Illinois Tollway Standard Drawing Revisions

Section C Guardrail and Concrete Barriers		
Drawing	Modification Summary	Effective: 03-01-2026
C1-14	GALVANIZED STEEL PLATE BEAM GUARDRAIL	
Sheet 1	Foreslope and backslope dimensions in Guardrail Installation Details sections were revised for clarity	
C2-02	CONCRETE BARRIER SINGLE FACE, REINFORCED TL-4, L-SHAPE 44 INCH

CONCRETE BARRIER SINGLE FACE, REINFORCED TL-4, L-SHAPE 44 INCH

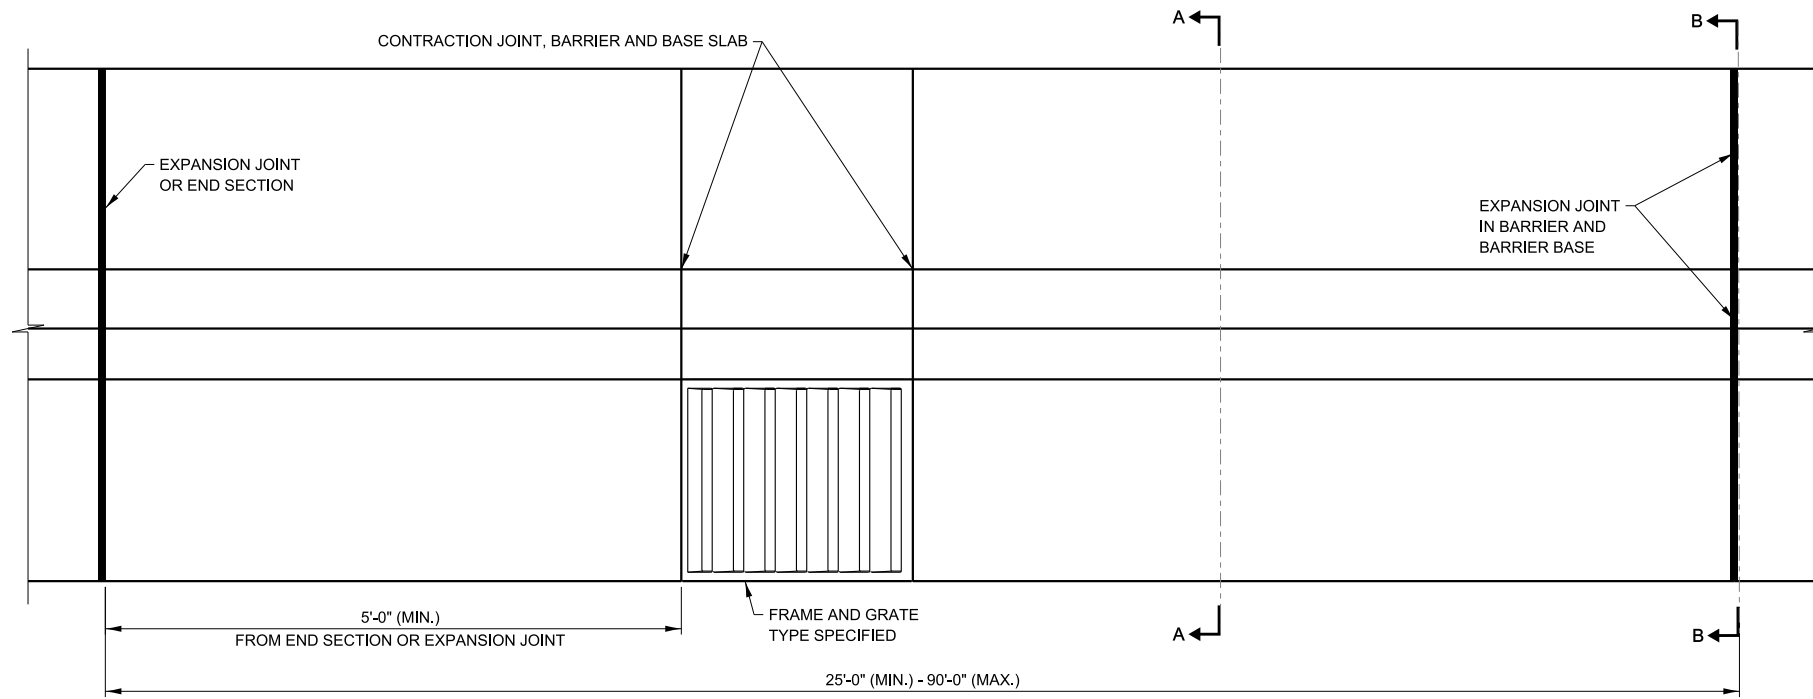
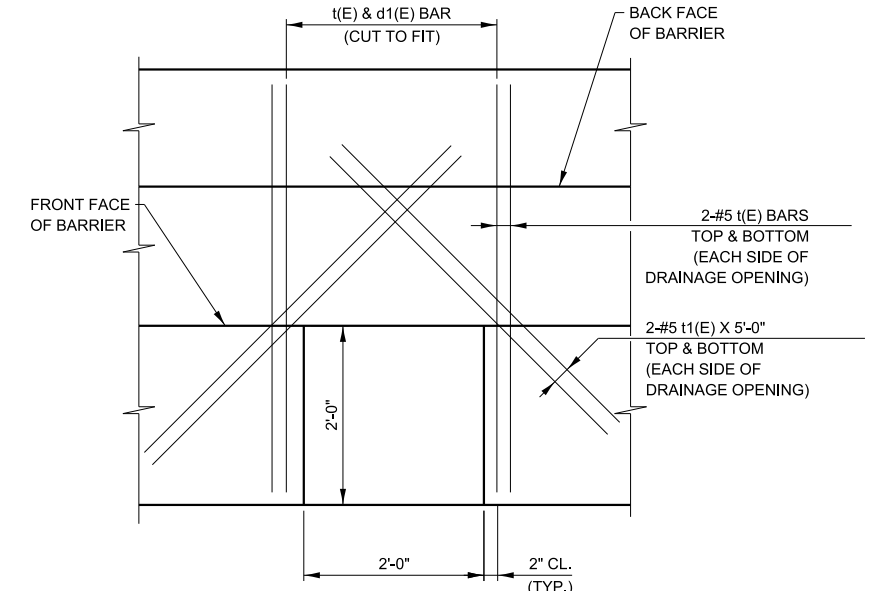
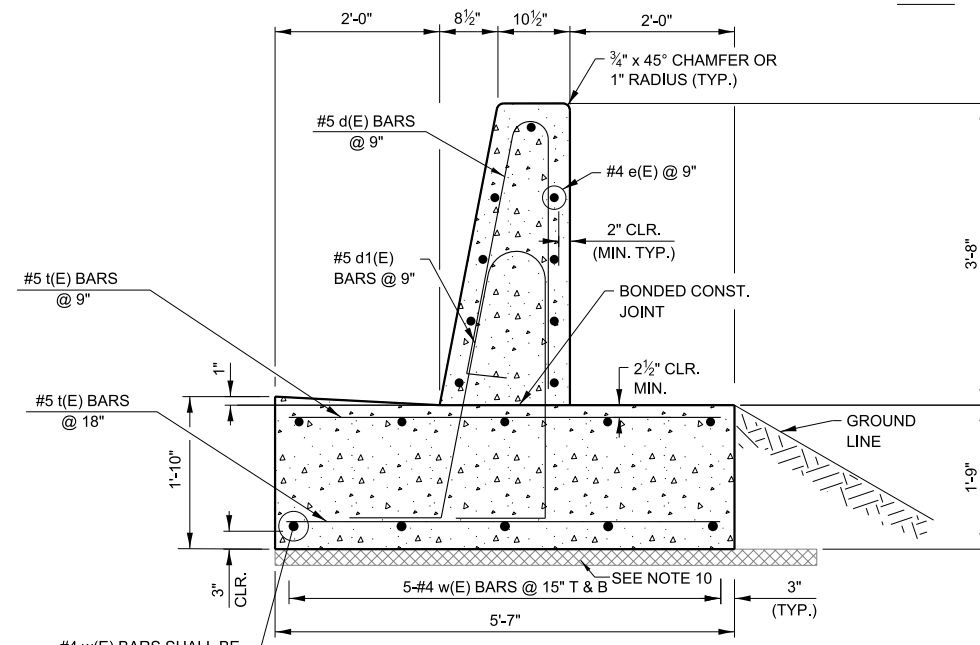
Sheet 1	Note 10 added to clarify subbase material under concrete barrier base	
C3-12	CONCRETE BARRIER SINGLE FACE, REINFORCED TL-4, 44 INCH	
Sheet 1	Note 10 added to clarify subbase material under concrete barrier base	
C6-12	SHOULDER WIDENING FOR TRAFFIC BARRIER TERMINAL, TYPE T1 (SPECIAL) TANGENT

- SUBBASE DIMENSIONS AND MATERIAL REQUIREMENTS UNDER CONCRETE BARRIER ARE SHOWN ON STANDARD B-24.

REVISIONS	
DATE	DESCRIPTION
03-01-2026	ADDED NOTE 10
03-01-2024	ADDED PJF BETWEEN BASE AND DRAINAGE STRUCTURE

**SHOULDER WIDENING FOR
TRAFFIC BARRIER TERMINAL,
TYPE T1 (SPECIAL) TANGENT**

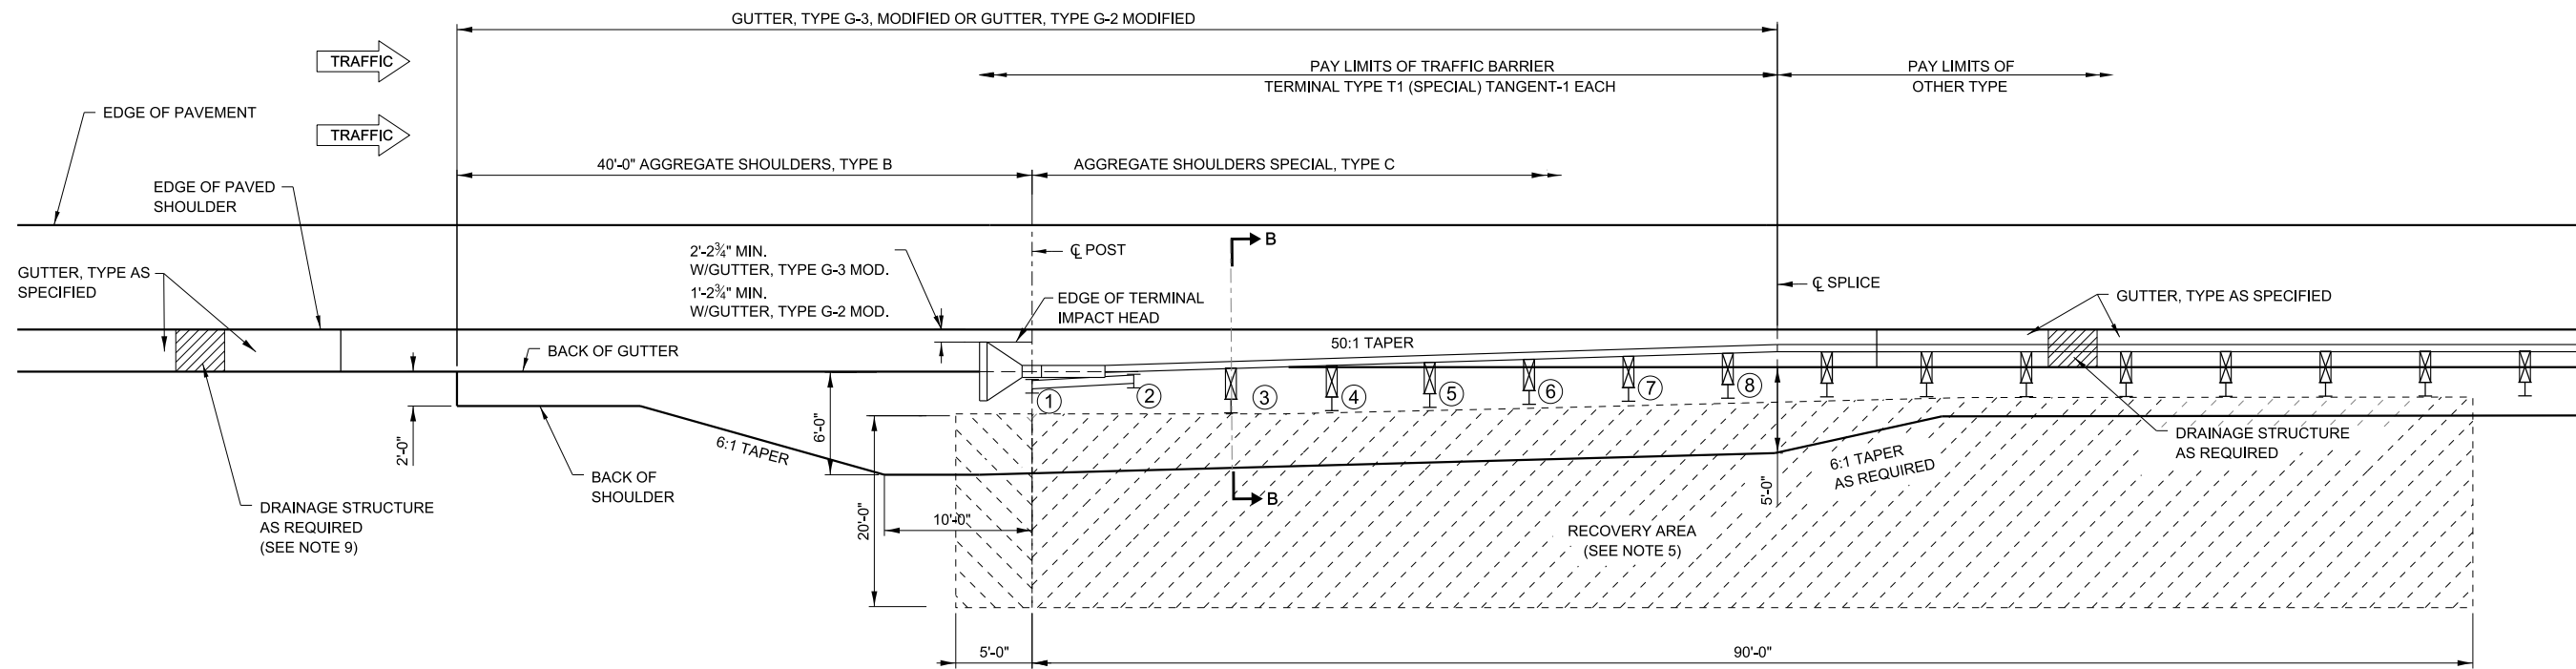
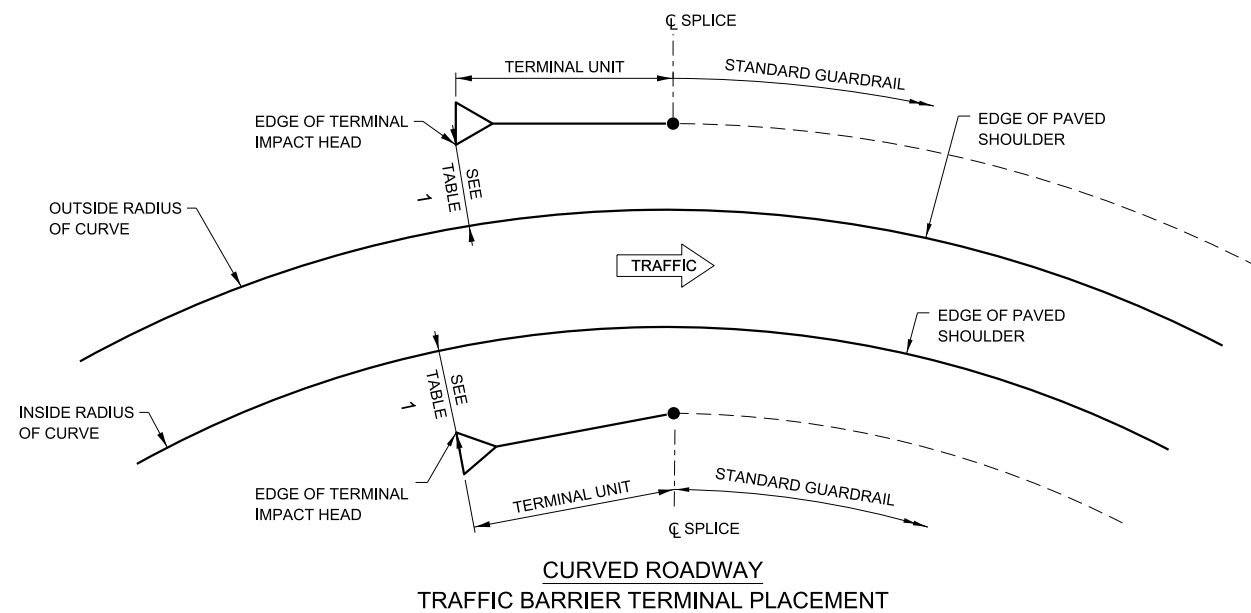
Sheet 1	Foreslope dimension in section A-A was removed for clarity	
Sheet 2	Foreslope dimension in section B-B was removed for clarity	
C7-09	TRAFFIC BARRIER TERMINAL, TYPE T2

REVISIONS	
DATE	DESCRIPTION
03-01-2026	REVISED SLOPE DIMENSIONS IN GUARDRAIL INSTALLATION
03-01-2020	ADDED MOD. TO TABLE 1 & PLAN NOTE
03-01-2019	REVISED NOTES FOR MASH
03-31-2017	REVISED NOTES

TRAFFIC BARRIER TERMINAL, TYPE T2

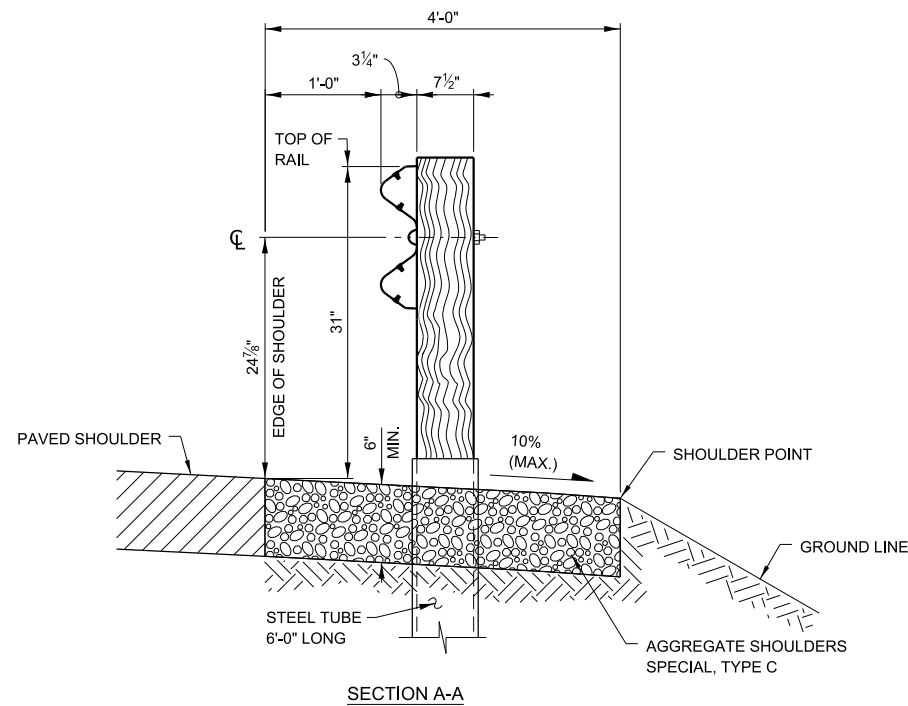
Sheet 2	Foreslope dimension in section B-B was removed for clarity	
C12-11	SHOULDER WIDENING FOR TRAFFIC BARRIER TERMINAL, TYPE T1-A (SPECIAL)	
Sheet 1	Foreslope dimension in section A-A was removed for clarity

REVISIONS	
DATE	DESCRIPTION
03-01-2026	REVISED SLOPE DIMENSIONS IN GUARDRAIL INSTALLATION
03-31-2017	REVISED SECT A-A SHOULDER SLOPE TO %
03-31-2016	REVISED SECTION A-A SHOULDER
03-11-2015	REVISED NOTES

CONCRETE MEDIAN BARRIER TRANSITION, TYPE V-DF AT BRIDGE PIERS

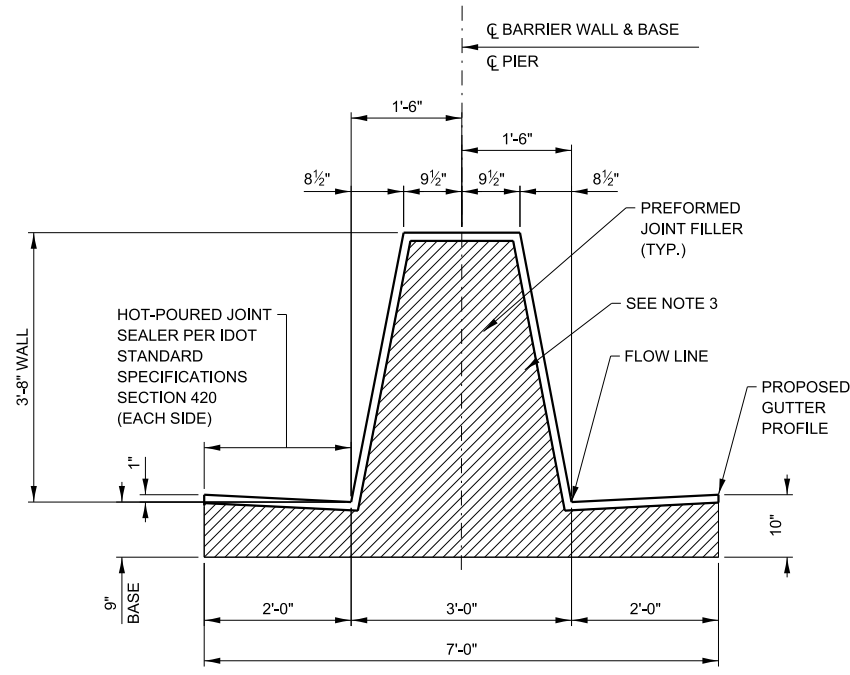
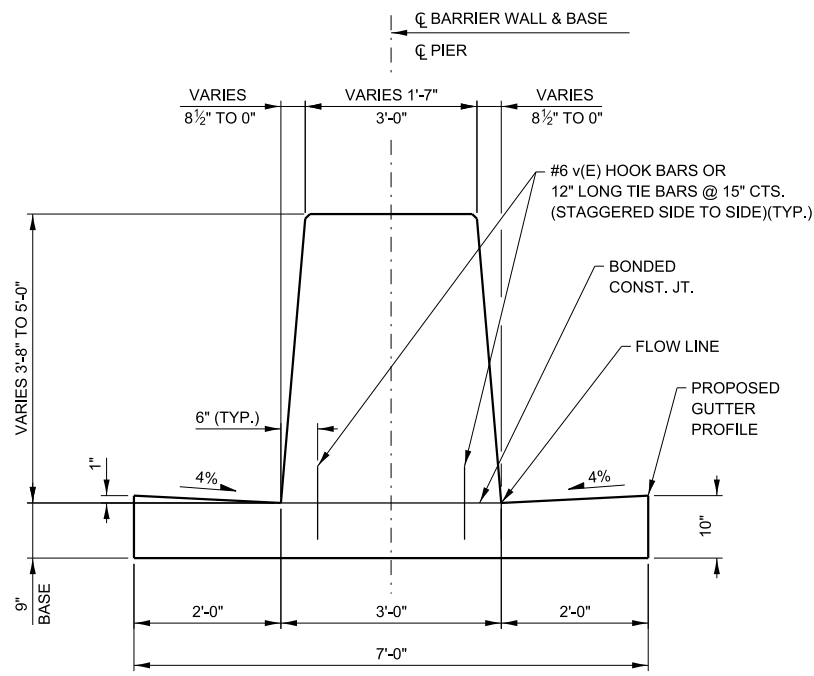
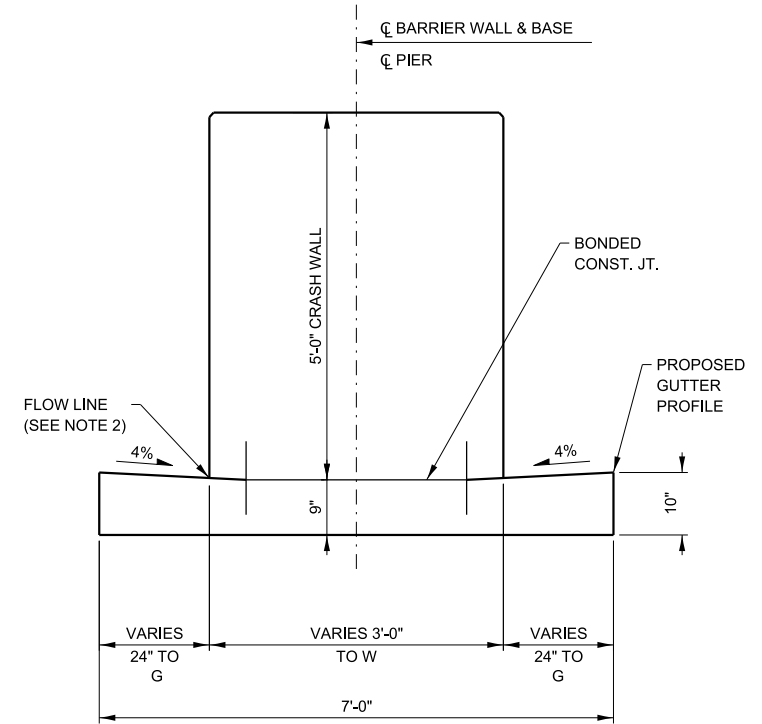
Sheet 2	Foreslope dimension in section B-B was removed for clarity	
C13-08	CONCRETE MEDIAN BARRIER TRANSITION, TYPE V-DF AT BRIDGE PIERS	
Sheet 2	Concrete Barrier dimensions in section A-A were revised for clarity	
C15-05	CONCRETE BARRIER SINGLE FACE, REINFORCED TL-5, T-SHAPE 44 INCH

CONCRETE BARRIER SINGLE FACE, REINFORCED TL-5, T-SHAPE 44 INCH

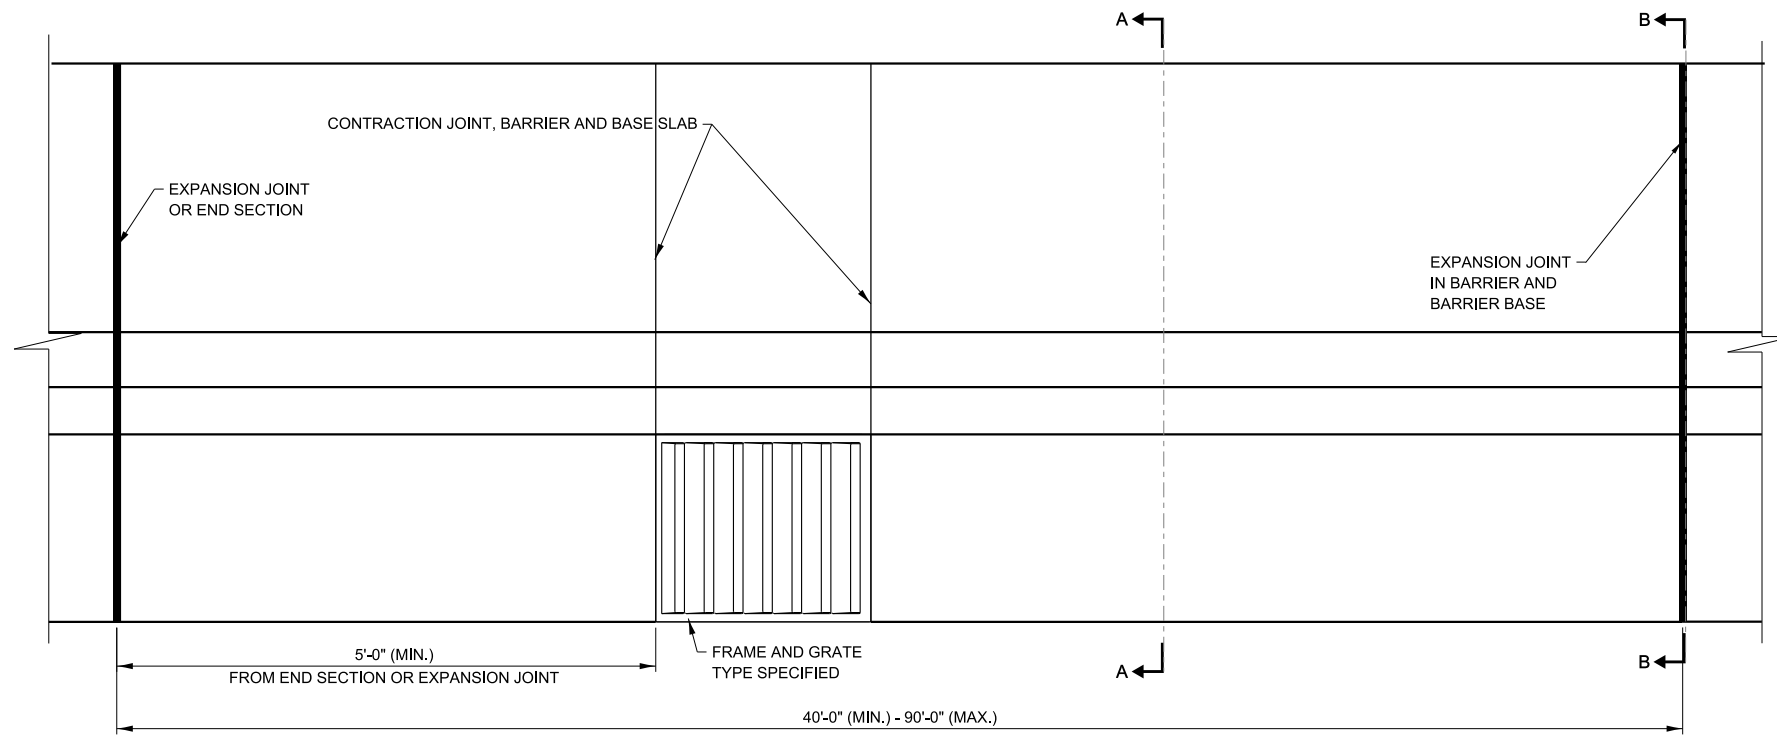
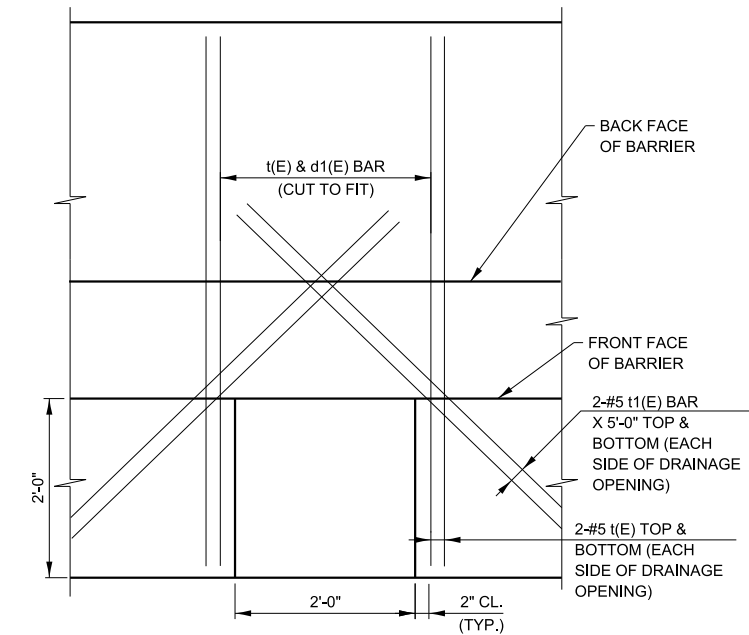
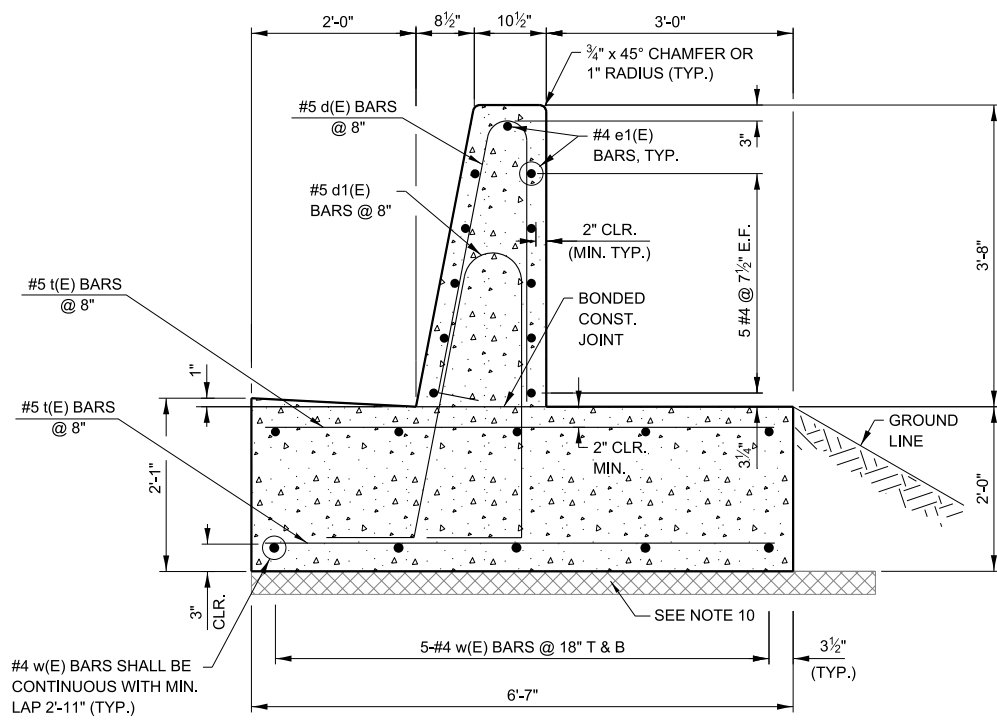
Sheet 1	Note 10 added to clarify subbase material under concrete barrier base	
C16-05	CONCRETE BARRIER SINGLE FACE, REINFORCED TL-5, L-SHAPE 44 INCH	
Sheet 1	Note 10 added to clarify subbase material under concrete barrier base	
C17-06	CONCRETE BARRIER SINGLE FACE, REINFORCED TL-5, 54 INCH

- WHEN SPECIFIED IN THE PLANS, THE BACKSIDE OF THE BARRIER BASE MAY BE LEFT EXPOSED A MAXIMUM OF 1", MEASURED FROM THE TOP OF THE BARRIER BASE.
- SUBBASE DIMENSIONS AND MATERIAL REQUIREMENTS UNDER CONCRETE BARRIER ARE SHOWN ON STANDARD B-24.

REVISIONS	
DATE	DESCRIPTION
03-01-2026	ADDED NOTE 10
03-01-2024	ADDED P.J.F BETWEEN BASE AND DRAINAGE STRUCTURES
03-01-2023	REVISED NOTE #1 AND REINF. DETAIL AT DRAINAGE STRUCTURES
03-01-2022	REVISED NOTES & CALLOUTS
